ADDENDUM 1 | Wilmette Public Library

BAS

Part One - Revisions to the Drawings

1 NETWORK LAYOUT
NO SCALE

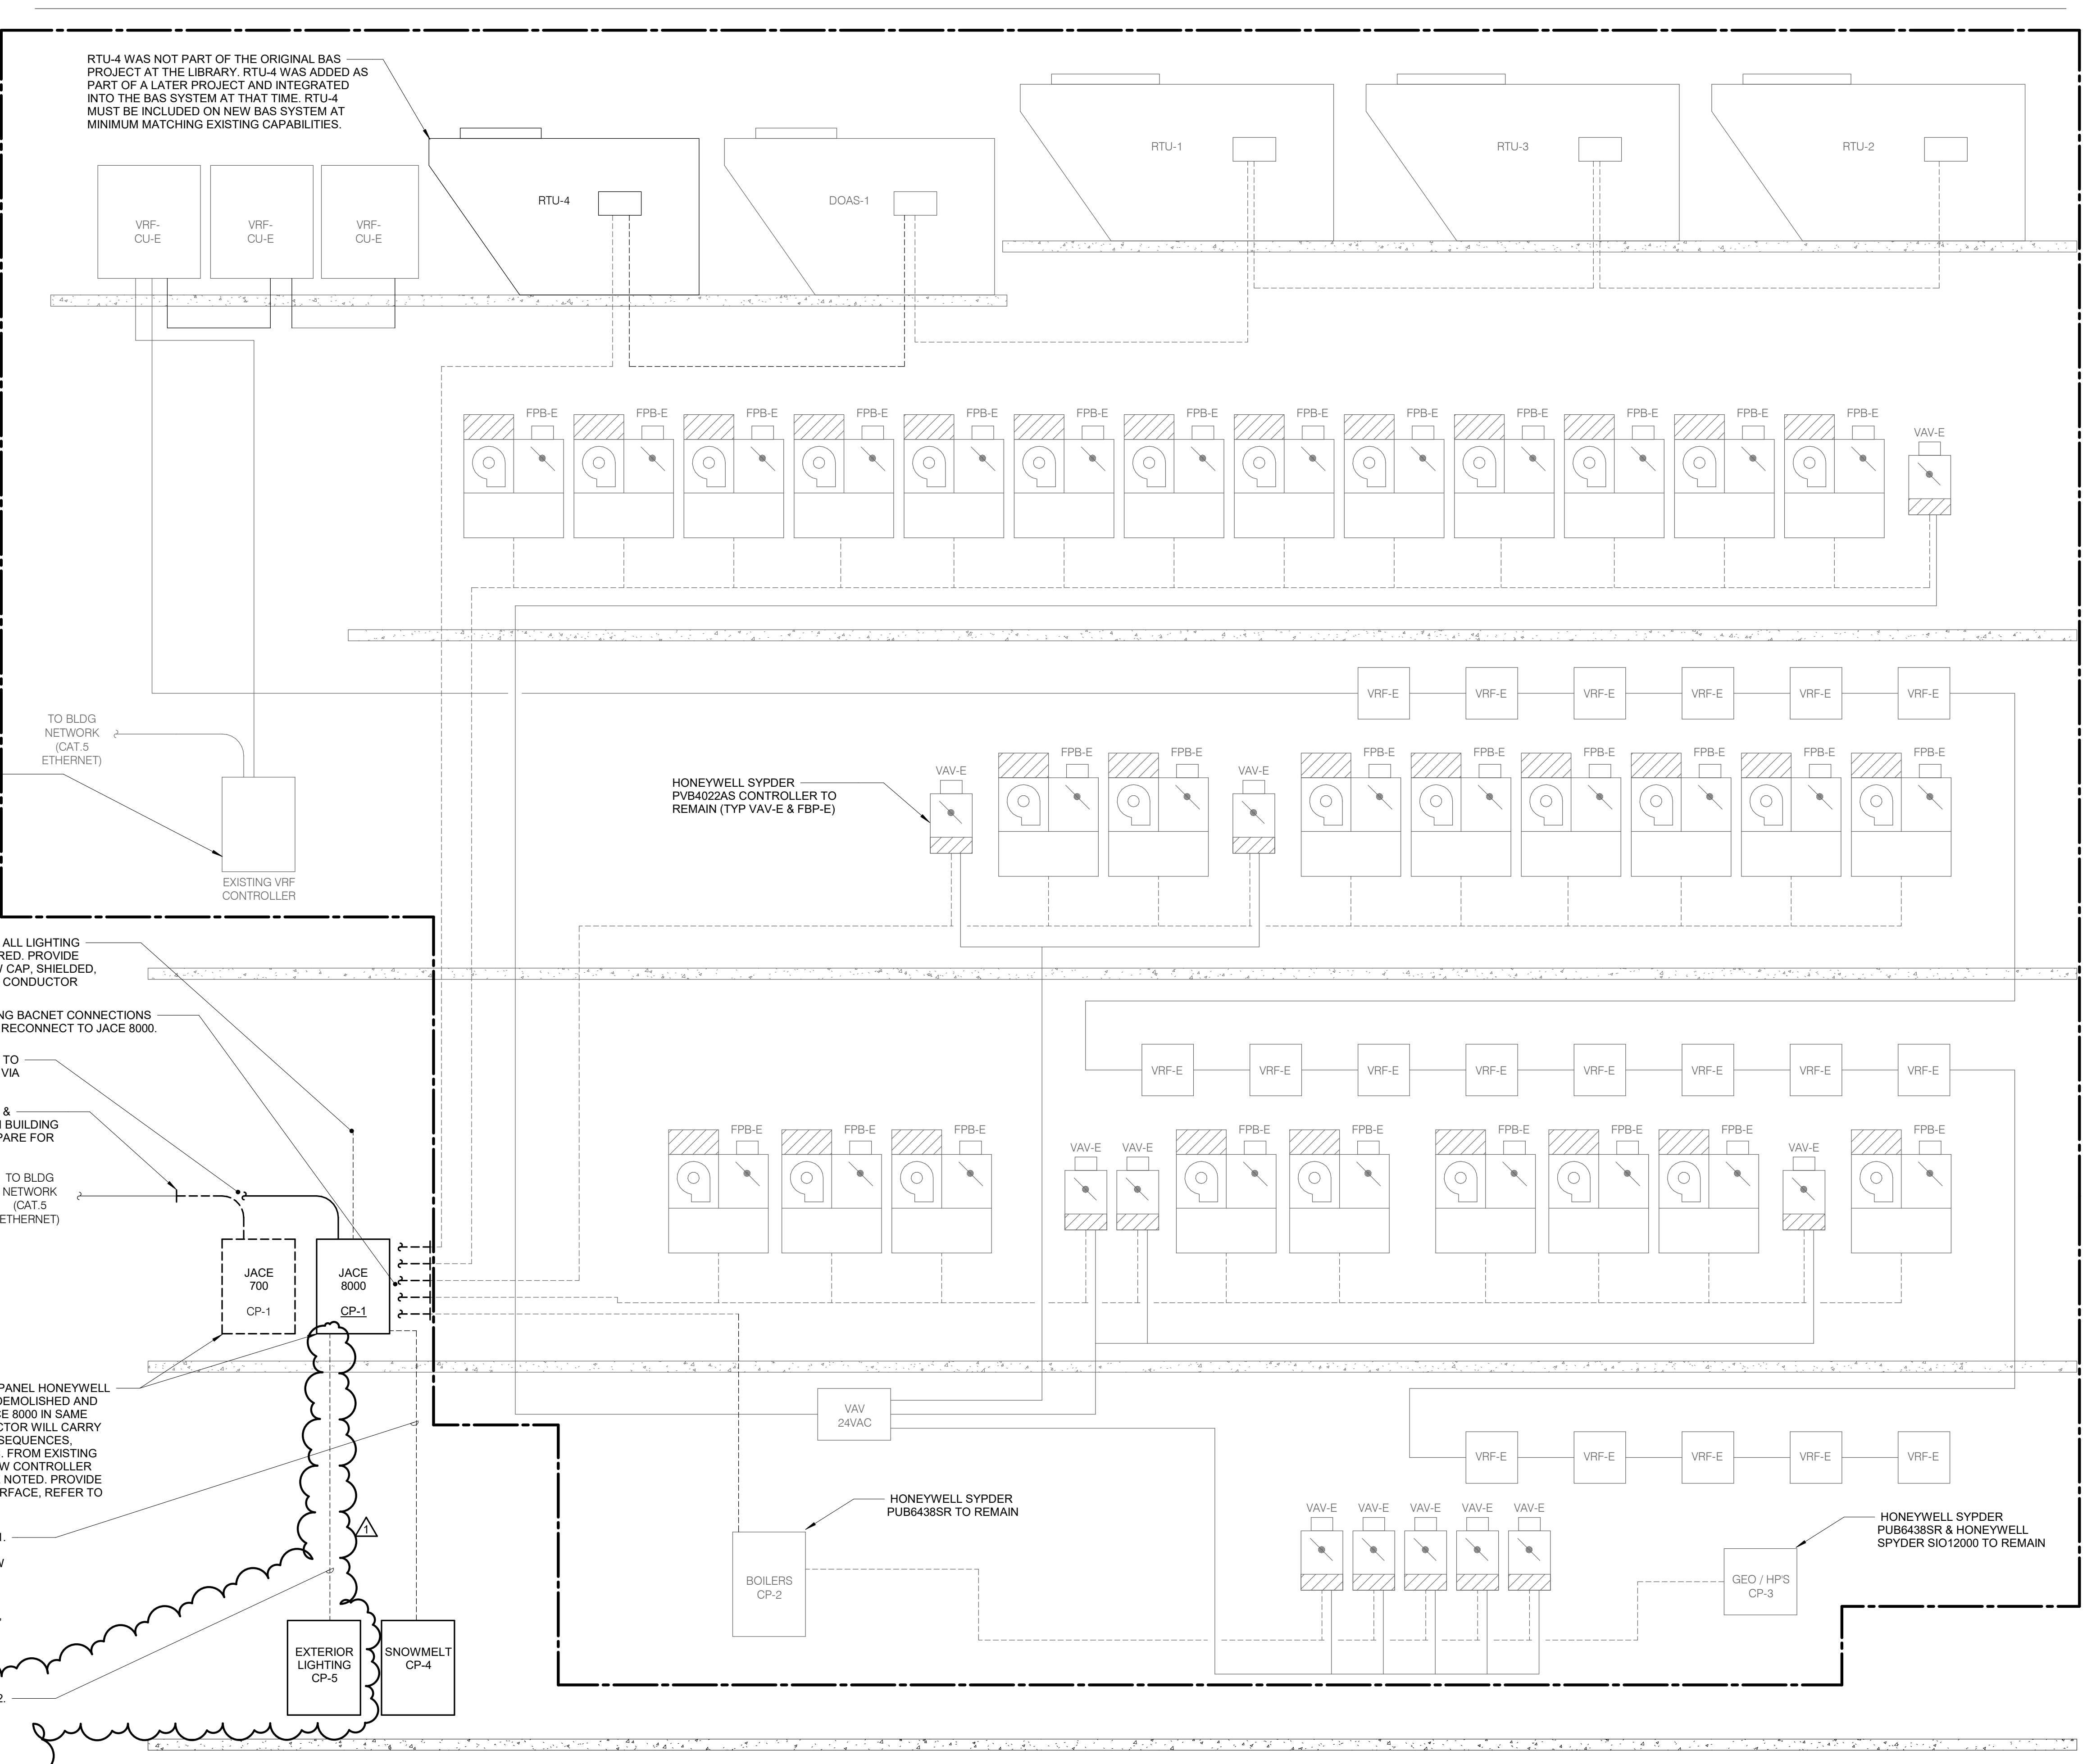
3. MC300
 - a. Update Network Layout to include CP-5 and associated wiring under Alternate 2.

UNDER ALTERNATE 2. CONNECT CP-5, INTERMATIC ET902150E AND INTERMATIC ET9500, TO NEW CP-1. PROVIDE MINIMUM BACNET COMM WIRE 22-1 PR. LOW CAP. SHIELDED, PLNEUM RATED, RWTISED PAIR, STRANDED CONDUCTOR WIRE.
